HISTORIC AND DESIGN REVIEW COMMISSION

July 19, 2017

HDRC CASE NO: 2017-341
ADDRESS: 1201 E CROCKETT ST
LEGAL DESCRIPTION: NCB 1373 BLK 1 LOT W 77.4 FT OF 9 & 10
ZONING: MF-33, H
CITY COUNCIL DIST.: 2
DISTRICT: Dignowity Hill Historic District
APPLICANT: Todd Worrich
OWNER: Todd Worrich/Tondra Ball, LLC
TYPE OF WORK: Exterior modifications, porch modifications, window replacement, fencing and rear carport construction

Crockett St. Elevation

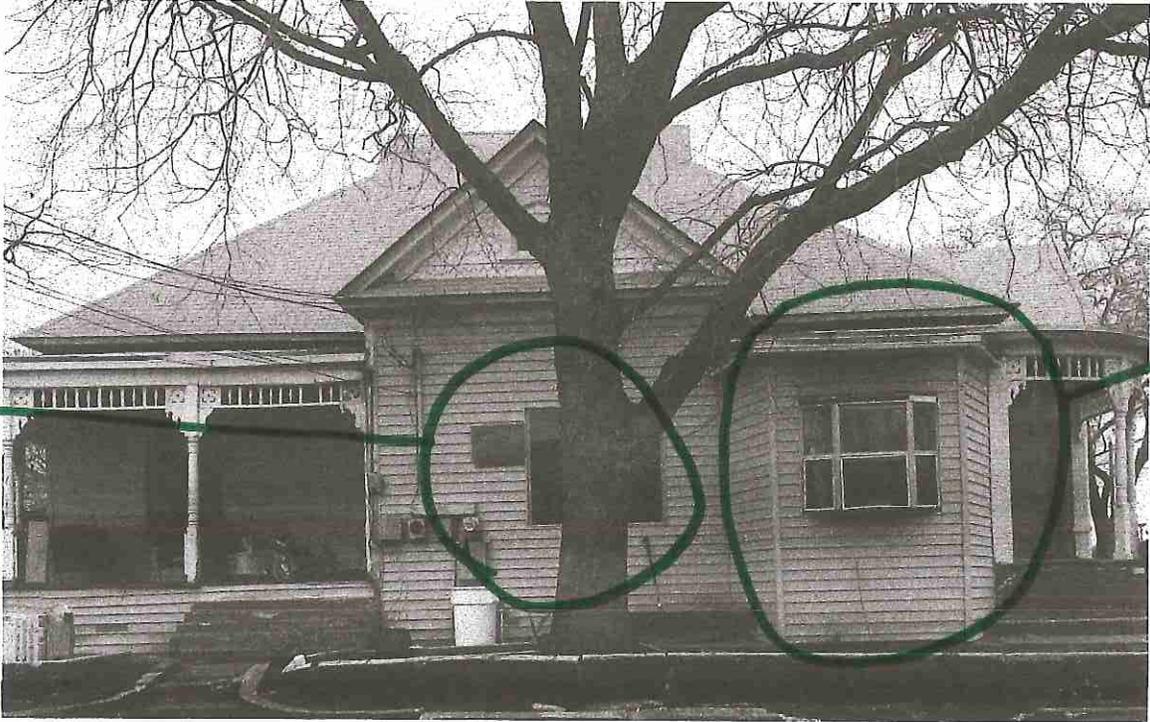
- e. BAY WINDOW REMOVAL – The applicant has proposed to remove a non-original bay window on the Crockett Street elevation and enclose the window opening. This window opening is not original to the historic structure. Staff finds its remove and the enclosure of the opening appropriate. Staff does not find this opening to be original given the inconsistent head and sill heights.

Patio enclosed

Bay Window added

Staff recommends approval of items #2 through #4, the removal of the front porch addition, the removal of the bay window on the E Crockett elevation and the removal of the non-original window opening on the N Pine elevation based on findings b through f with the following stipulations:

"Crockett Street View"
South Elevation
1201 E. Crockett St.

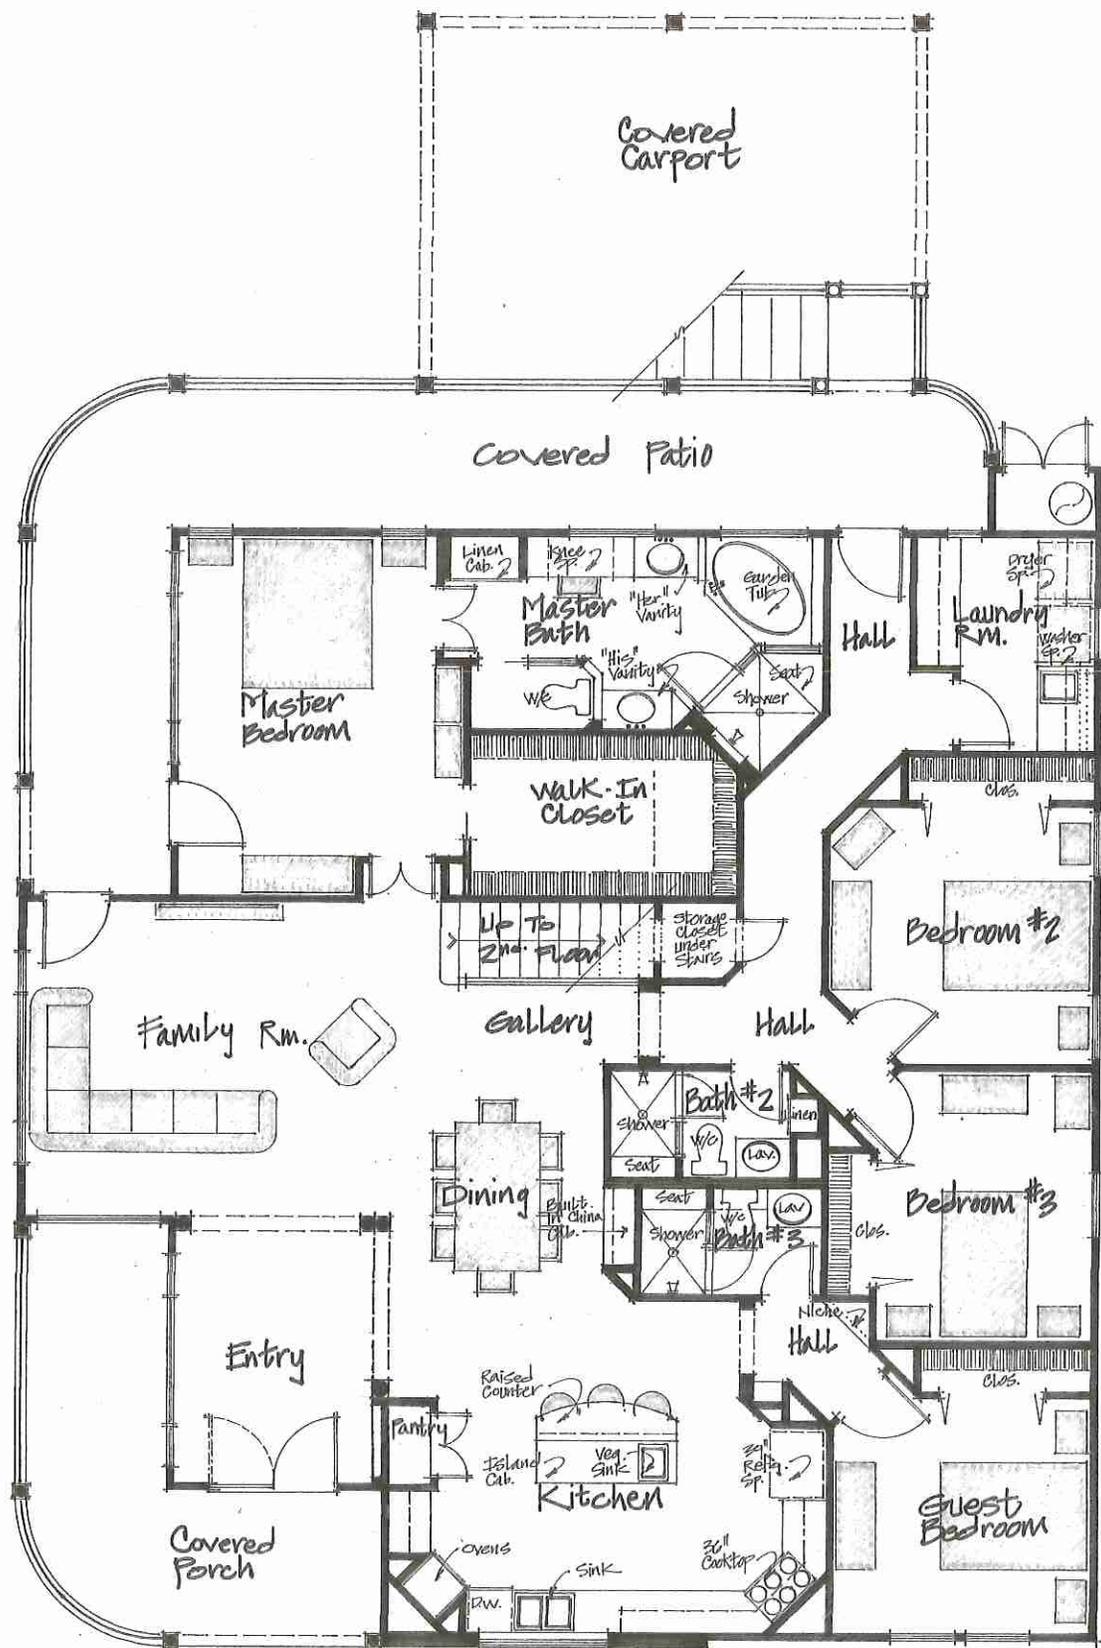
- c. FRONT PORCH RESTORATION – With the removal of the front porch addition’s walls, the applicant has proposed to create new window openings which include a large picture window on the western side of the south porch elevation and double front porch doors. The Guidelines for Exterior Maintenance 6.B. ii and iv. note that new entrances should be compatible in size, material and profile of the historic element. Additionally, new windows should match the historic or existing windows in terms of size, type, configuration, material, form, appearance and detail. The front porch currently features a side, front door. Folk Victorian structures in San Antonio commonly feature both side, front doors and street facing front doors. Staff finds that a single width door to match the existing porch door would be architecturally appropriate to install on the front porch.

- d. FRONT PORCH RESTORATION – The applicant has proposed to remove the side yard facing, front porch door and install a large fixed widow with two narrow one over one windows on each side, similar to a Chicago Style window. Side yard facing front porch doors are vernacular to Folk Victorian structures in San Antonio. Staff finds that the applicant should maintain this original door opening. Regarding the proposed window installation, staff finds this window installation inconsistent with the Folk Victorian style and inconsistent with the Guidelines for Exterior Maintenance and Alterations 6.B.iv.

- f. FIXED WINDOW REMOVAL – To the north of the enclosed patio, on the E Crockett elevation, the applicant has proposed to remove a non-original, fixed window and install a larger fixed widow with two narrow one over one windows on each side, similar to a Chicago Style window. Staff finds the existing window installation as well as the proposed inconsistent with the Queen Anne style and inconsistent with the Guidelines for Exterior Maintenance and Alterations 6.B.iv.

Staff does not recommend approval of item #1, the enclosure of the side facing front door, based on finding d. Staff recommends the applicant maintain the side facing front porch door.

- i. That the applicant install window openings that are consistent with the Queen Anne style in locations where non-original window openings exist.
- ii. That the applicant install a single width, street facing front door to match the profile of the side yard facing front door as noted in finding c.

Proposed 1st. Floor,
 Floor Plan
 Preliminary Designs

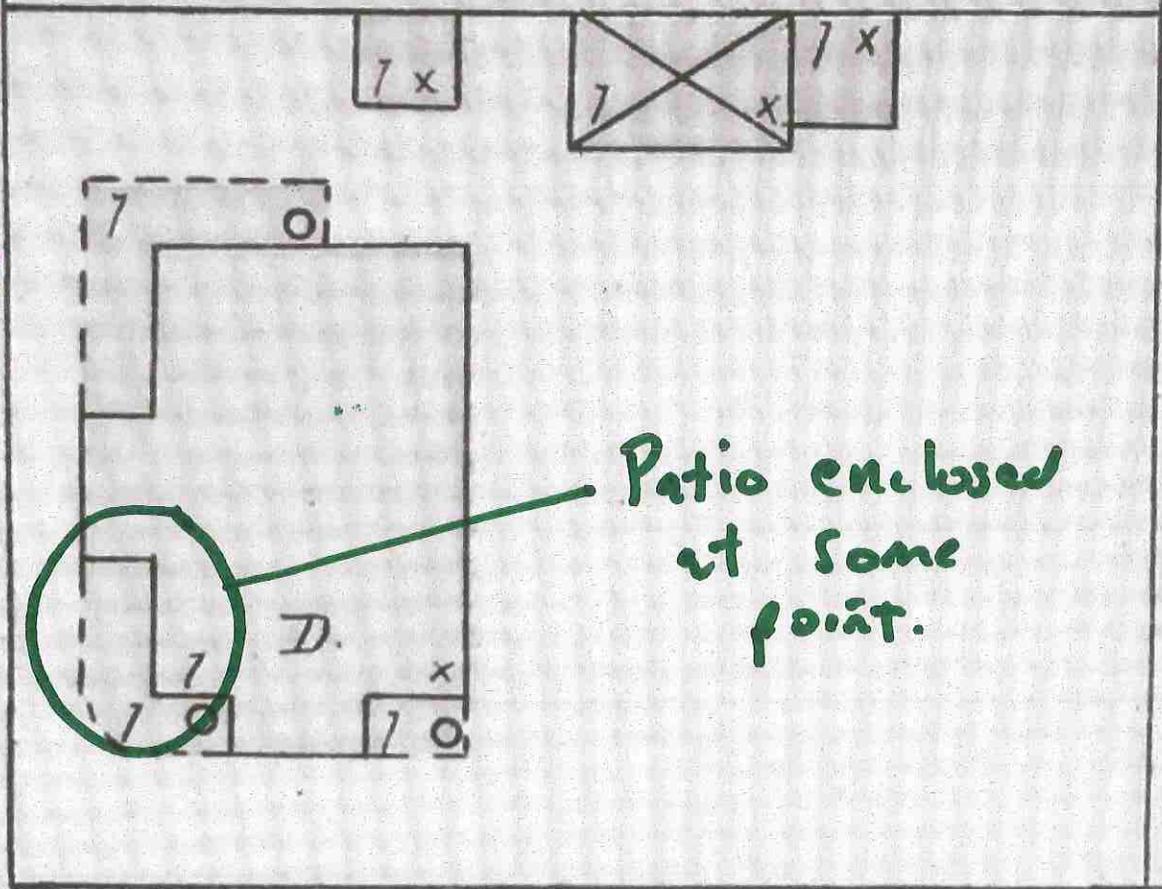
- m. REAR CARPORT – On the north side of the lot, the applicant has proposed to construct a carport to be attached to the primary historic structure. The applicant has proposed for the carport to feature architectural elements to match that of the Folk Victorian Structure. The proposed carport will feature a shed roof, similar to that of the primary historic structure’s wraparound porch. The carport will feature a massing and setback that is subordinate to both of the primary historic structure. Staff finds this proposal appropriate and consistent with the Guidelines.

Staff recommends approval of item #11, the construction of a carport with the stipulation that the applicant simplify the proposed decorative elements to complement, but not match those of the primary historic structure.

LEGAL DESCRIPTION

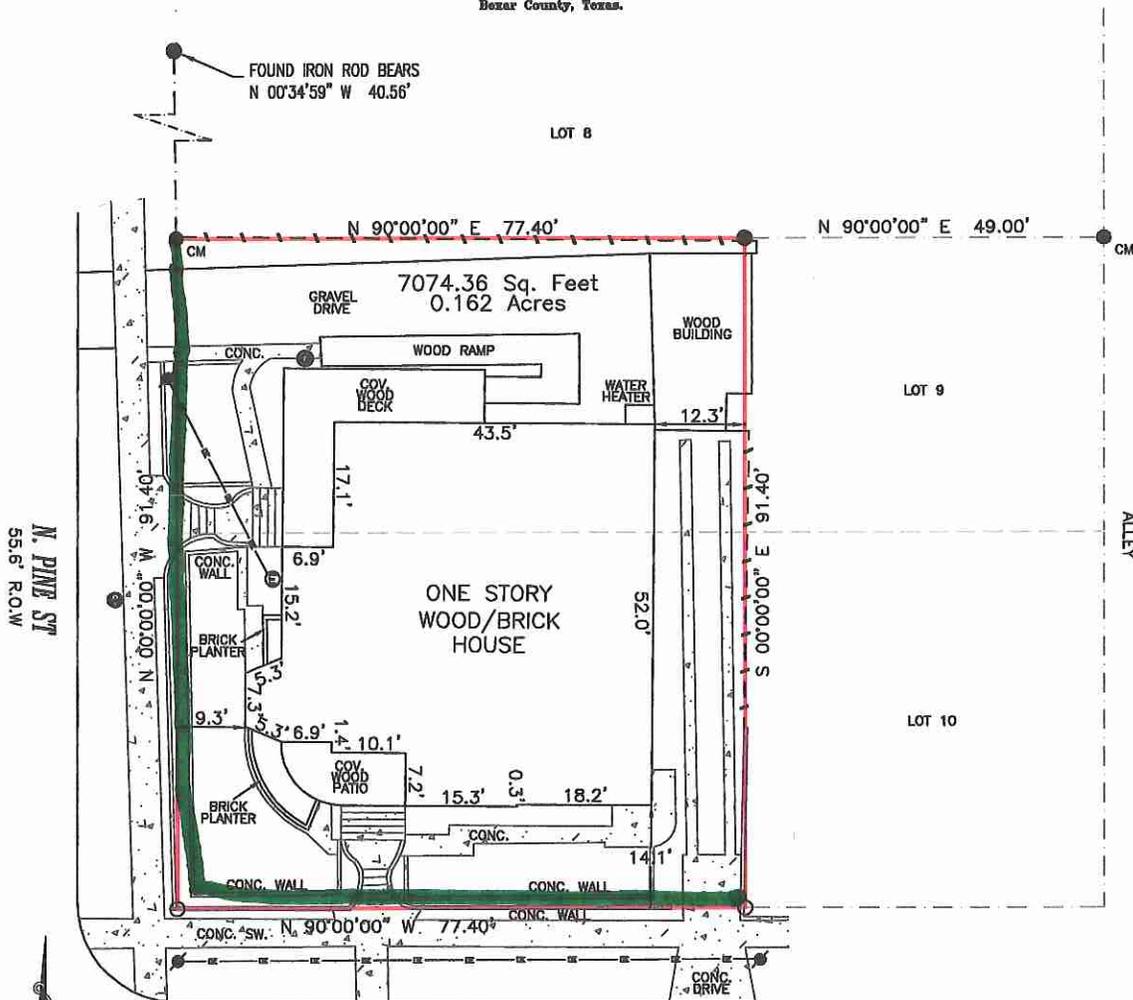
- l. WROUGHT IRON FENCING – Atop the retaining wall, the applicant has proposed to install a wrought iron fence. The applicant has not specified a specific fence height; however, the existing retaining wall is approximately 40 inches in height. Retaining walls are a common front yard elements along E Crockett due to slope and draining conditions. Recently, fences have been approved by the HDRC for installation atop retaining walls on E Crockett. Staff finds that the applicant should install a fence consistent with the height of the neighboring fence.

add fence on top existing retaining wall. Fence to be 4'

Staff recommends approval of item #10, the installation of front yard fencing based on finding l with the stipulation that the height of the proposed fence match that of the neighboring property.
